DN-110.1
EN-56
FN-42

SERVICE BULLETIN

DATE: 27 OCTOBER 1989
PAGE 1 OF 8

INSPECTION AND MODIFICATION OF PN 369D292028, AFT PASSENGER STEP ASSEMBLIES, ON EXTENDED LANDING GEAR ASSEMBLIES; AND INSPECTION AND MODIFICATION OF AFT LANDING GEAR FOOT ASSEMBLIES

Figure 1. Inspection of Aft Extended Landing Gear Step and Strut Assemblies

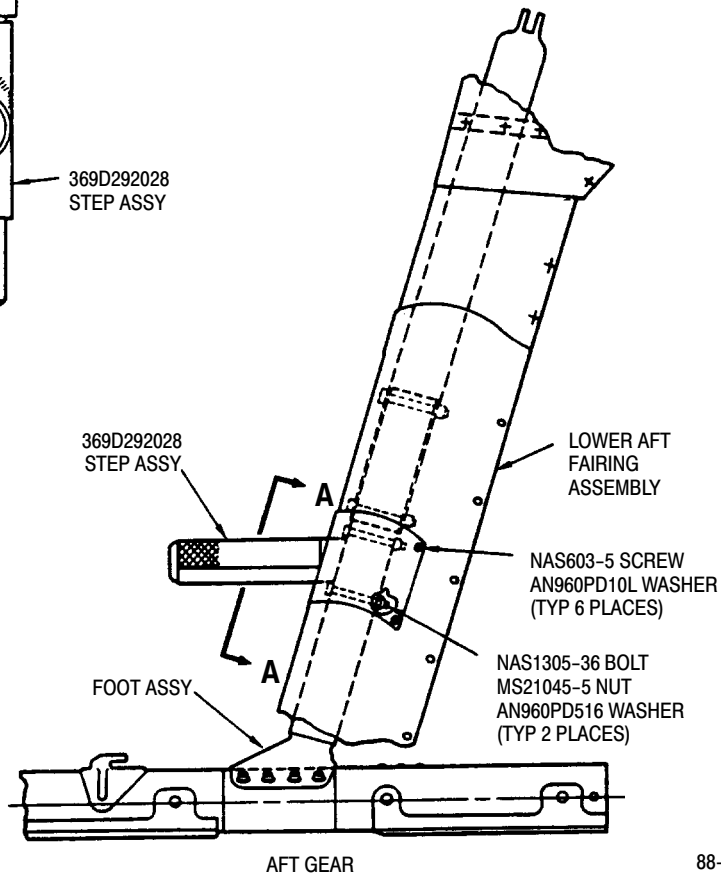
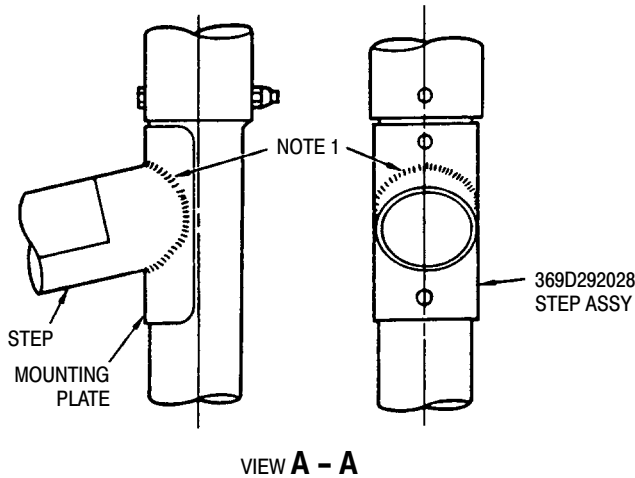
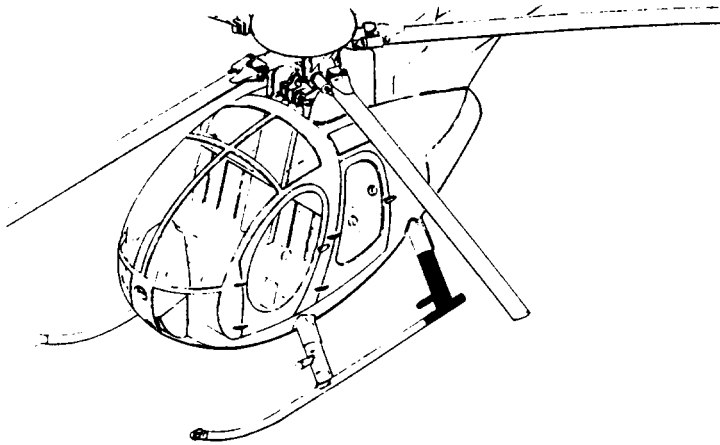
- (1). Remove screws and washers securing cover assembly to lower fairing on aft extended landing gear assemblies; remove cover. (See Figure 1.)
- (2). Apply a 400 pound proof load on step, approximately one inch from outboard end during inspection.
- (3). Using 10X magnifying glass or dye penetrant inspection, inspect top area of weld where step is attached to mounting plate for possible cracking or damage (View A-A). Removal of paint is not required.

1. CHECK TOP AREA OF WELD WHERE STEP ATTACHES TO MOUNTING PLATE. USE 10X MAGNIFYING GLASS.
2. TO OBTAIN ACCESS TO INSPECT WELD AREA, REMOVE (6) SCREWS AND WASHERS SECURING COVER TO LOWER FAIRING.

Figure 2. Rework of Aft Landing Gear Assemblies

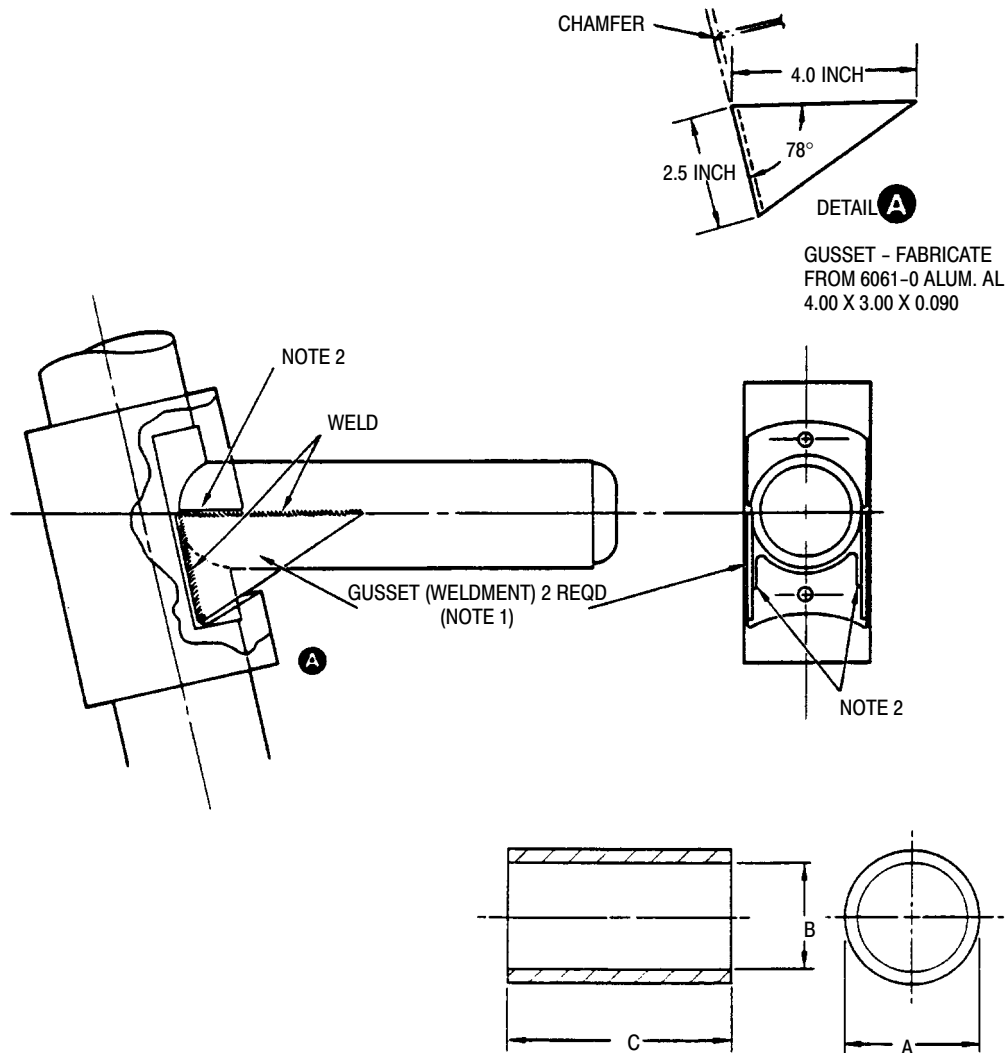
- (5). Heat step assembly to 200 degrees F to break bond on end cap. Remove end cap from step assembly.
- (6). Fabricate two gussets (per step assembly) to dimensions shown in Figure 2. Weld gussets to step and mounting plate as shown. Re-heat treat step assembly to T-62 condition per MIL-H-6088.

GUSSET - FABRICATE FROM 6061-0 ALUM. AL 4.00 X 3.00 X 0.090

1. FABRICATE GUSSETS FROM 6061-0 ALUM AL PER DIMENSION SHOWN.
2. TRIM FAIRING COVER AS REQUIRED TO CLEAR GUSSETS.
3. FABRICATE WITH 2024-T4 ALUMINUM ALLOY.
4. CONTOUR OUTER FACE OF BUSHING TO MATCH STRUT ASSEMBLY FWD SIDE ONLY (+0.000/-0.001).
5. SURFACE FINISH OF BUSHING AND HOLES TO BE 125 RPM.
6. CHEMICAL FILM TREAT BUSHING AND HOLE I.D.'S PER MIL-C-5541.

Figure 3. Plain Bushing/Hi-Shear Blind Nut Rework

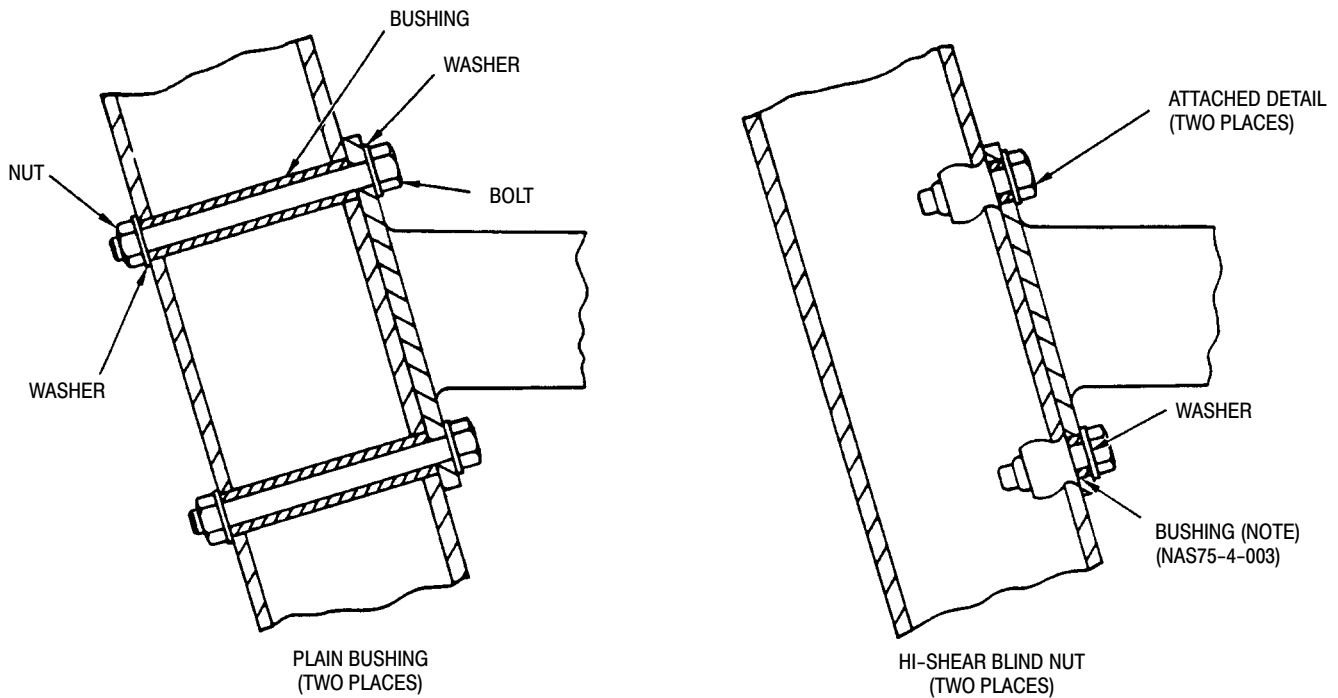
- (1). Ream 0.322/0.329 inch diameter hole through foot assembly at step attachment bolt hole locations to 0.4062/0.4082 inch diameter.
- (2). Fabricate bushing (two per step assembly) per the following instructions and Figure 3:

- (a). Machine stock material to a dimension that will provide 0.0000/0.0005 interference with 0.4062/0.4082 inch diameter holes
 - (b). Ream inside stock material. Inside diameter to be 0.322/0.329 inches in diameter concentric to O.D. (± 0.002).

- (c). Cut material to a length equal to the outside diameter of foot assembly at the bolt holes.
 - (d). Contour outer face of bushing to match the contour of the foot assembly (fwd side only, $+0.000/-0.001$).

- (e). Surface finish of bushing and holes to be 125 RMS or better. Deburr bushing a maximum of 0.015 inches.
 - (f). Chemical treat bushing and hole inside diameters per MIL-C-5541.

- (1). Ream 0.322/0.329 inch diameter holes through foot assembly (2 places) to 0.391/0.397. inch diameter (forward side only).
- (2). Countersink hole 100 degrees and minimum depth for flush installation of Hi-Shear blind nut BNB1100-12-3-5. Apply chemical. film per MIL-C-5541 to inside diameter of holes.
- (3). Ream 0.322/0.329 inch diameter hole (2 places) in step assembly to 0.375/0.377 inch diameter. Apply chemical film to hole per MIL-C-5541. Install NAS75-4-003 bushing with wet zinc chromate primer (TT-P-1757).
- (4). Install step assembly using (2) each, NB1100 bolts and AN960KD416 washers (Hi-Shear BNB1100-12-3-5 includes NB1100 bolt) as shown in Figure 3. Torque bolts 60 - 85 inch lbs.

- (5). Seal the nut head on forward side and bolt on aft side of foot assembly. Completely seal faying surfaces of step assemblies with PR 1436 sealant.
- (6). Reinstall cover assembly on affected fairing assembly with existing hardware. Trim cover assembly, as required, to clear gussets.
- (7). Record compliance with Part III of this Notice in the Compliance Record section of the helicopter Log Book.
